ISC-C1 Rack

Title ISC System Wiring Diagram		
Size B	Number D1900511	Revision V7
Date: 8/24/2022	Sheet of 1	38
File: C:\Users\...ISC_C1_SH1.SchDoc	Drawn By: Filiberto Clara

ISC-R1 Rack

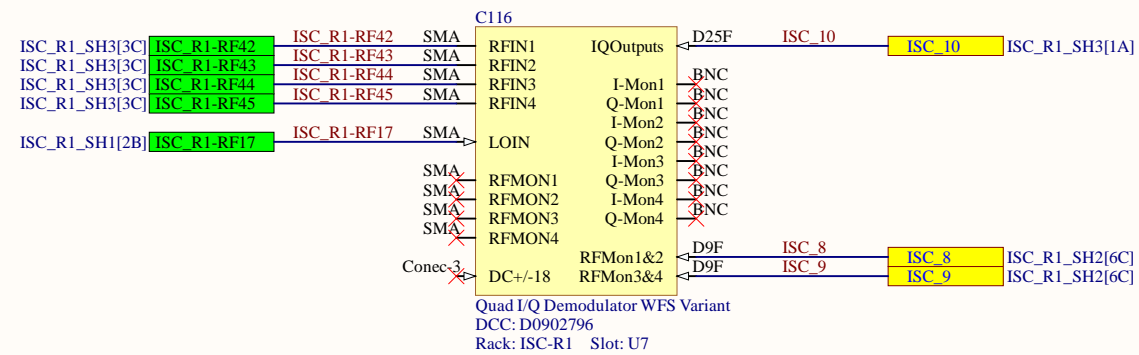
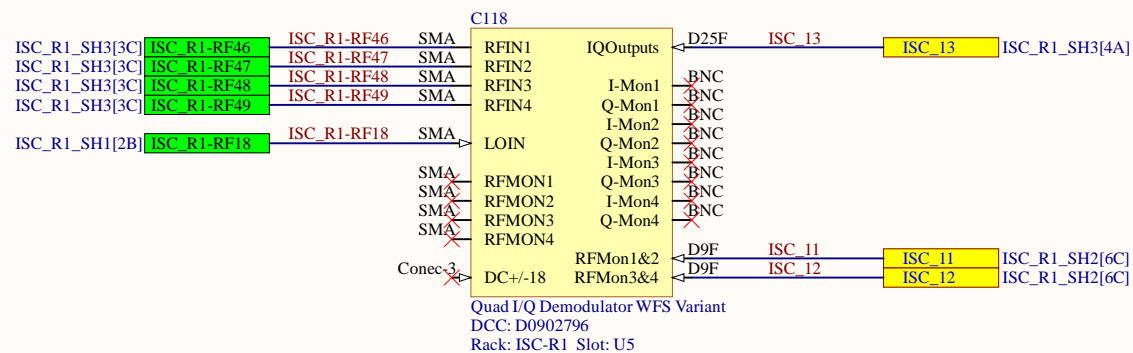
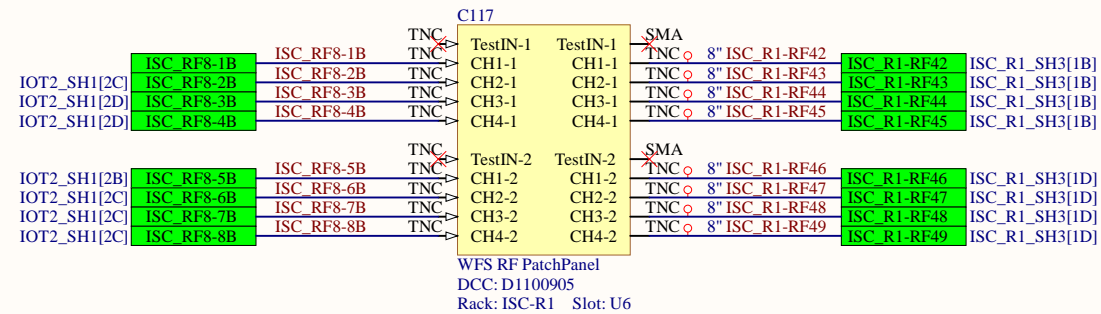
Need to locate other end

434/435 already used
 ASC-POP_X_PIT/YAW

ISC-R4 Rack

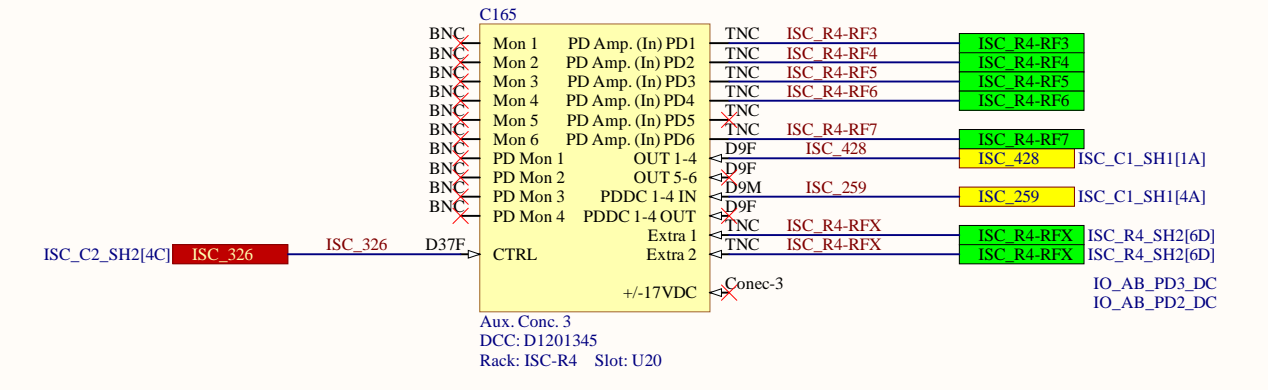
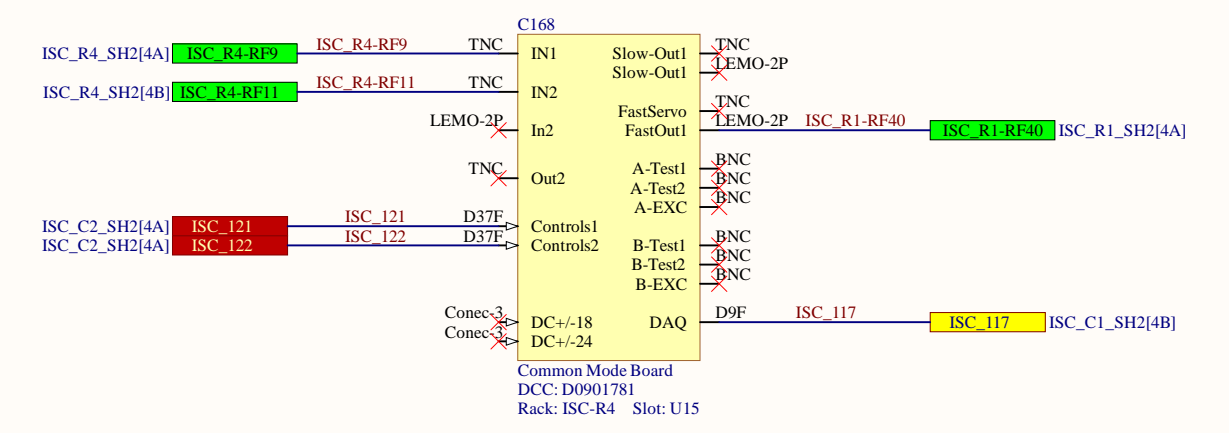
Otherside not labeled. RED
Otherside not labeled. Green
Otherside not labeled. R4 ISC1
Otherside not labeled. R4 ISC2
Otherside not labeled. Old label H1_ALS_PSL_PD1

ISC-R3 Rack

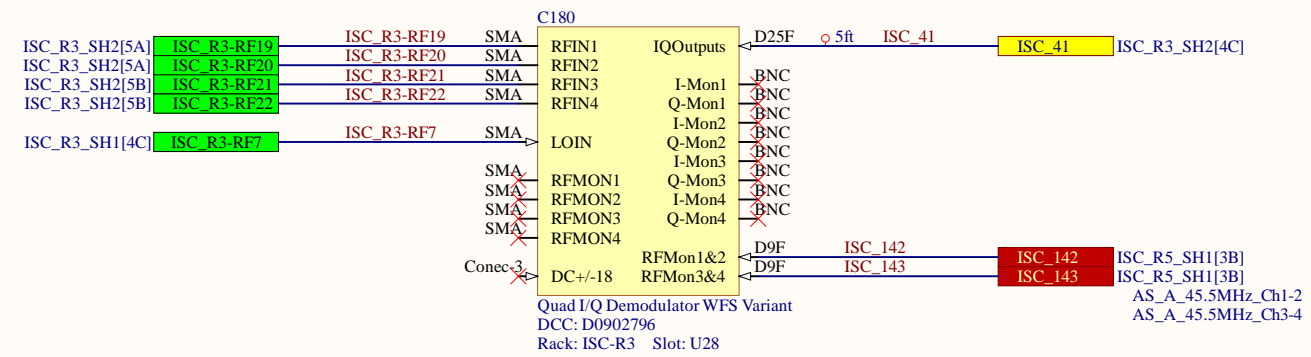
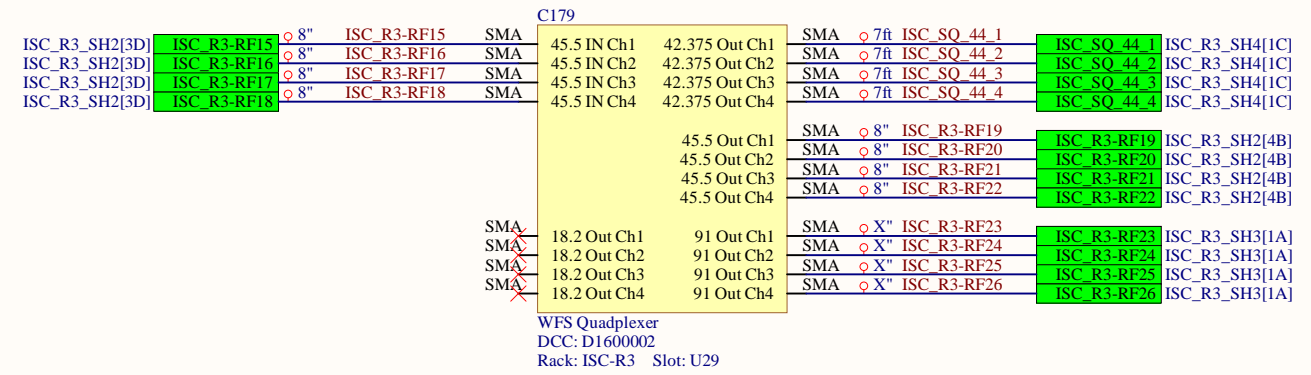
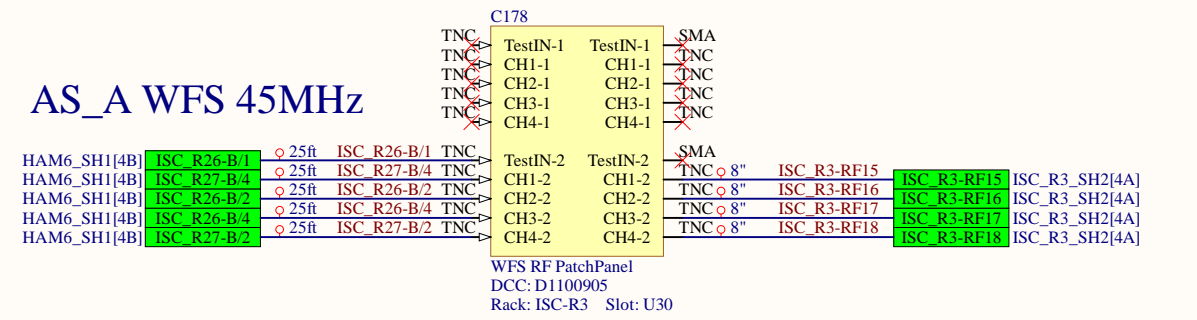
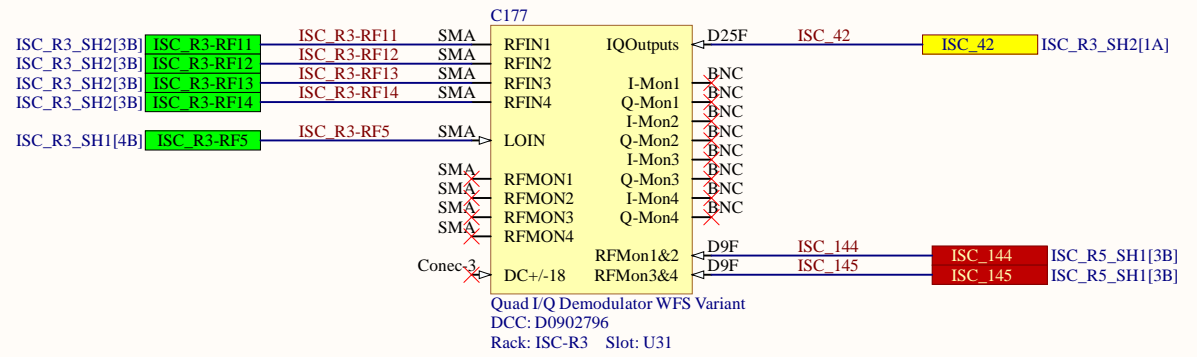
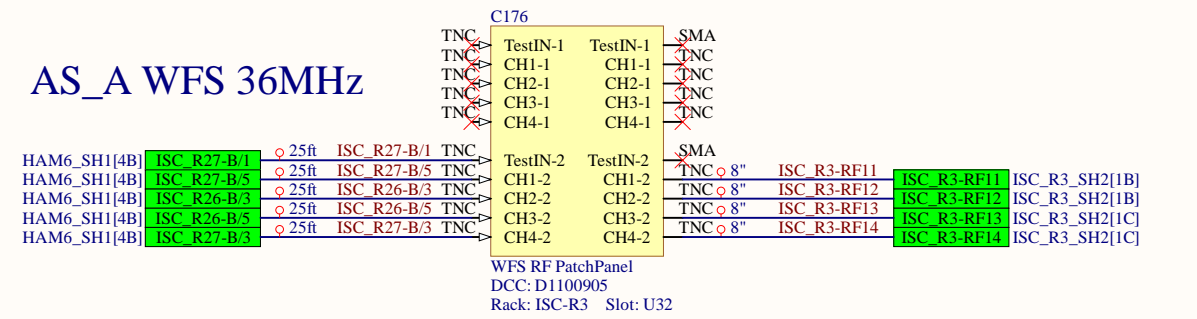
Need to Relabel ISC_R3-RF4

ISC-R3 Rack

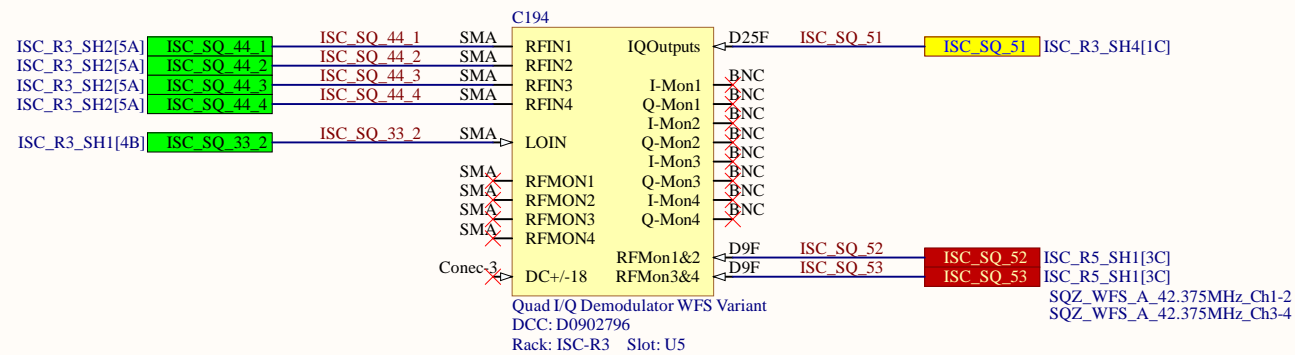
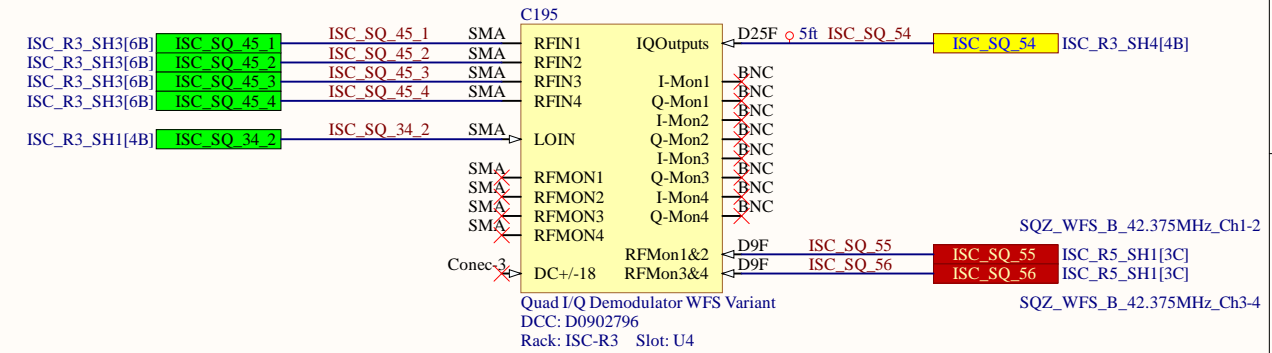
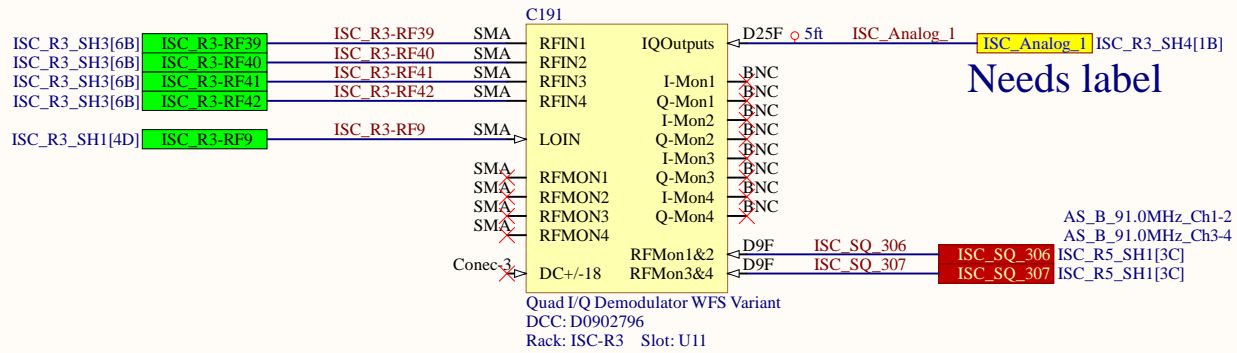
Needs labels

Needs label

HAM6 Flange Layout

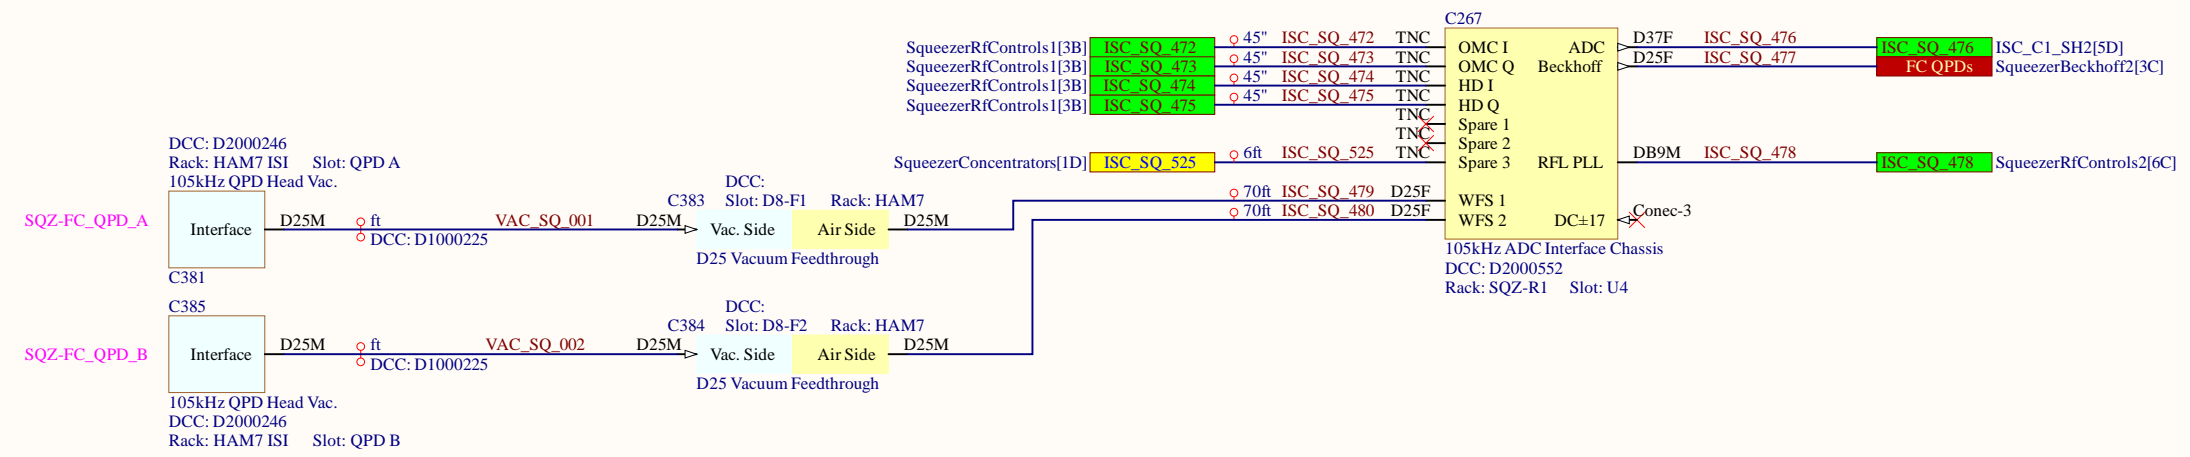
Cable ISC-235 not connected

Need to check WFS RF!

D1700308 Wiring Diagram - More Cables

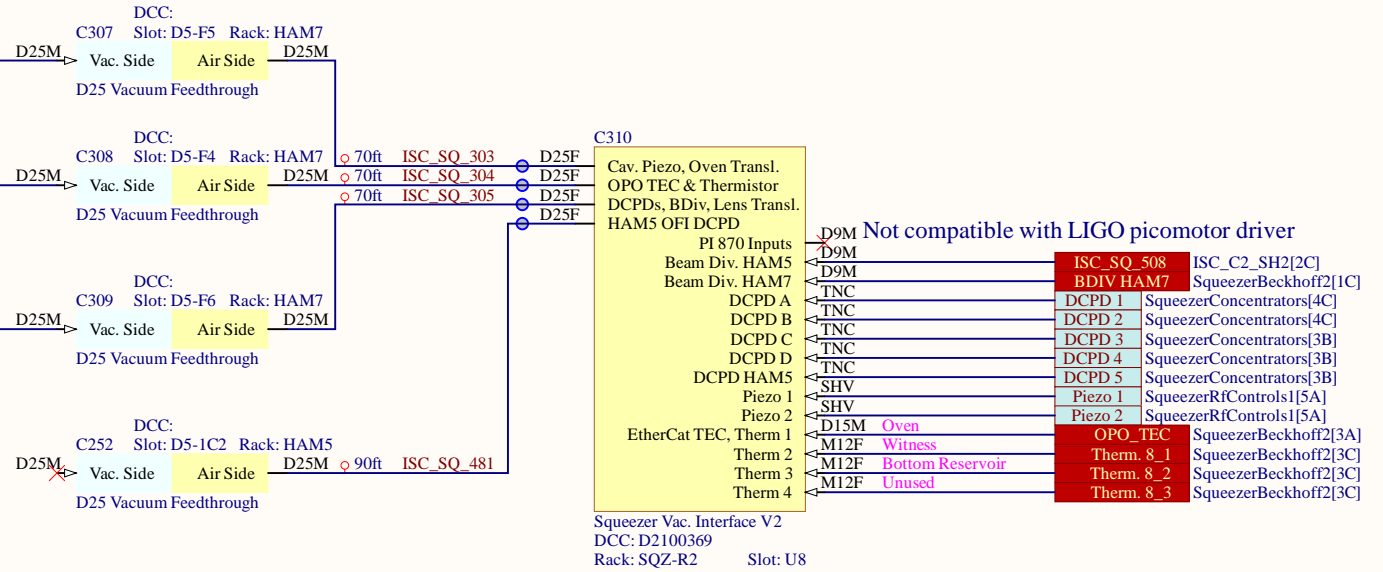
HAM5 DCPD
Beam diverter?

Title		
Squeezer RF Distribution		
Size	Number	Revision
C	D1900511	V7
Date:	8/24/2022	Sheet of 31 38
File:	C:\Users\...SqueezerRfDistribution.SchDb\Drawn By: R. Abbott

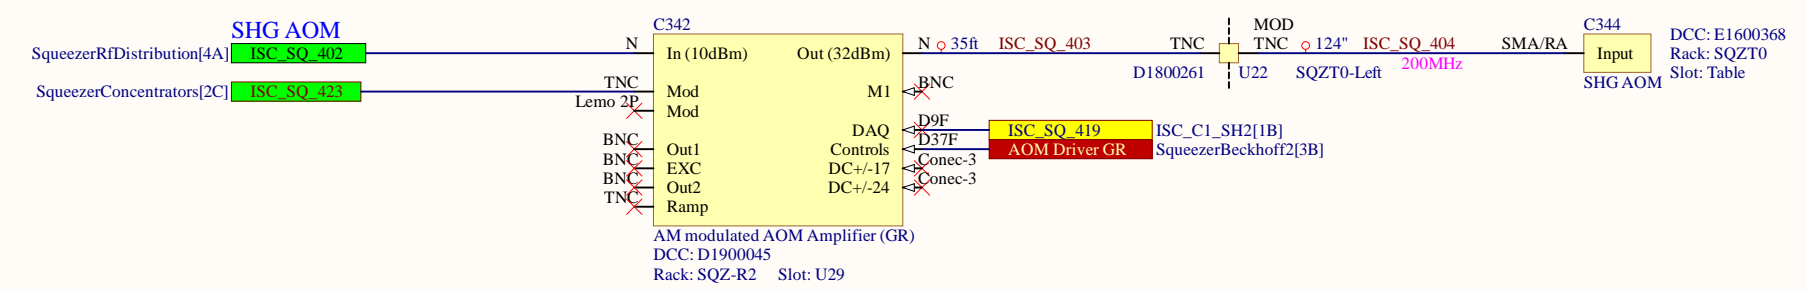
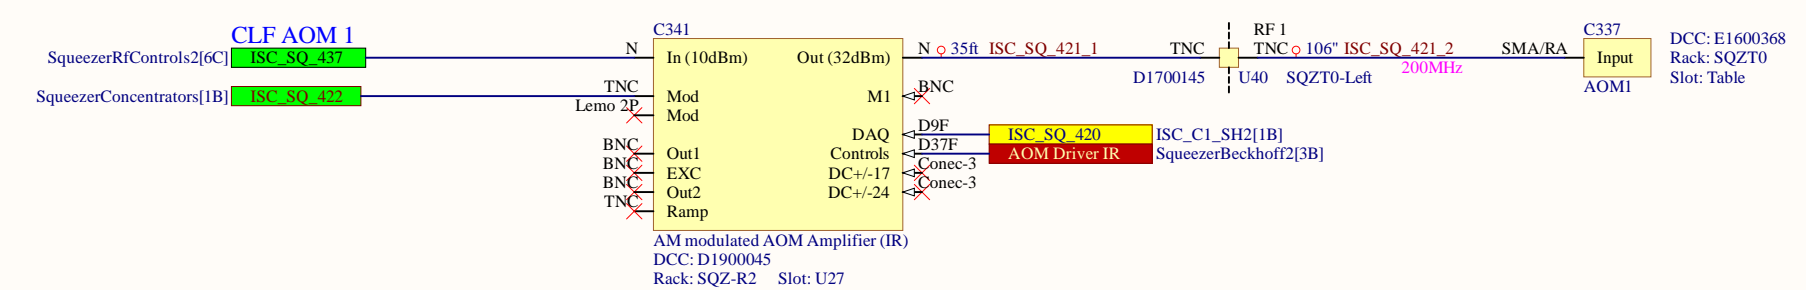
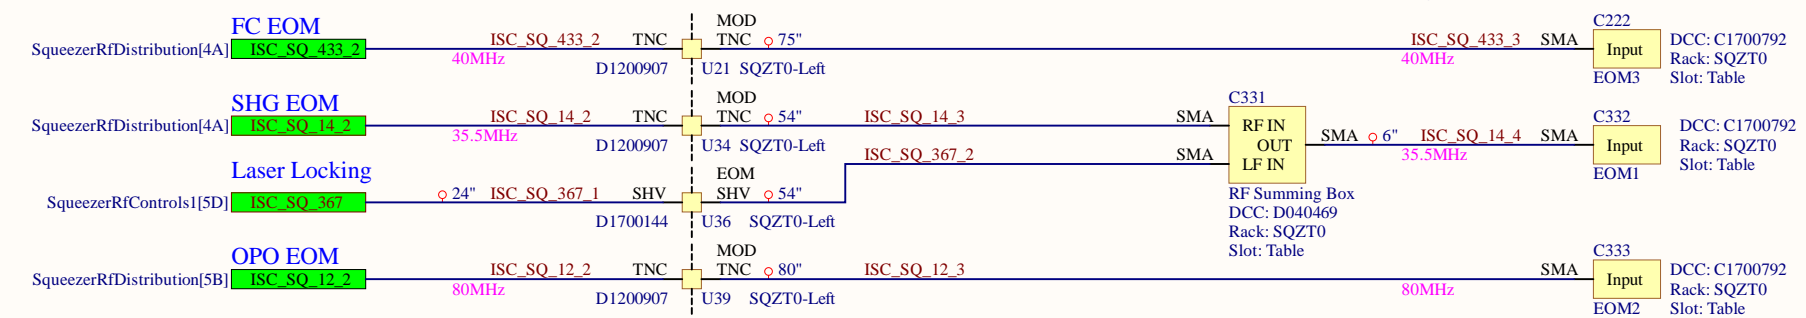
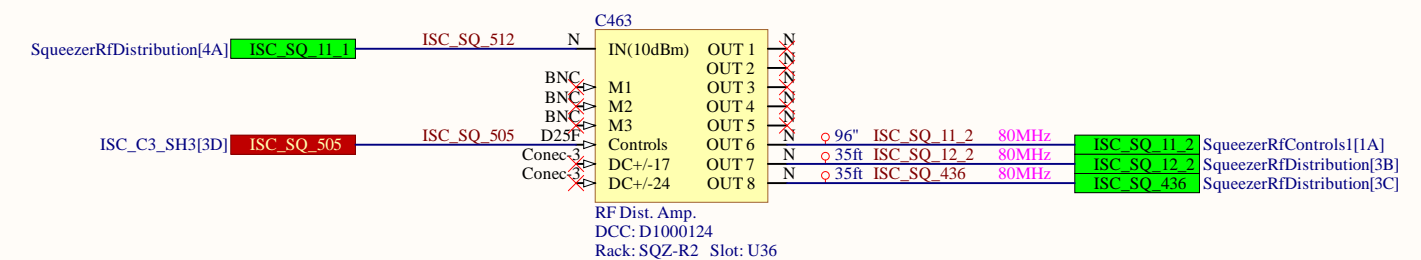
New cables for A_ start at ISC_SQ_430

RF cables carrying the AOM signals need to be 1/4" superflexible helical corrugated coax.
